Access Compliance Report

Public Rights-of-Way

Intersection ID: 11603	Main Street: AVENTIDE_LN	Cross Street: SERENADE_CT	Location: NE
ADA ID: 0ACB9BE8FB8B	Ramp Type: BlendTrans1	Initial Pass/Fail: Pass	Overall Compliance: No
Severity Score: 17.5			
Codes/Mitigation Info/Possible Solution		Field Measurements/Component Compliance

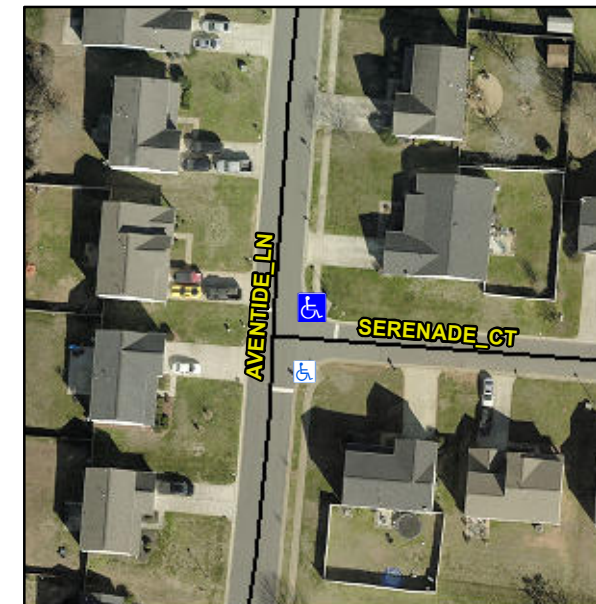
CURB WIDTH 47.0, NO RT SW

Not Found, R304.2.1, R304.2.2-Perp, R304.3.2-Para, R305, R302.7.2

N/A	Ramp inside XWalk1?	N/A	N/A	Ramp inside XWalk2?	N/A
	Road Slope (%)	0.1		Clear Space?	Yes
	Road X Slope (%)	0.0	N/A	Clear Space to XWalk (in)	N/A
Yes	Any Obstructions?	No	Yes	Storm Grate/Utility Hazard?	No
	Obstruction Type			Storm Grate/Utility Type	
		N/A			N/A
			Yes	Surface Condition? (G/P)	Good
			No	Curb Slope (%)	13.7

Remove & Replace Curb Ramp With Two New Directional Ramps or Equivalent.
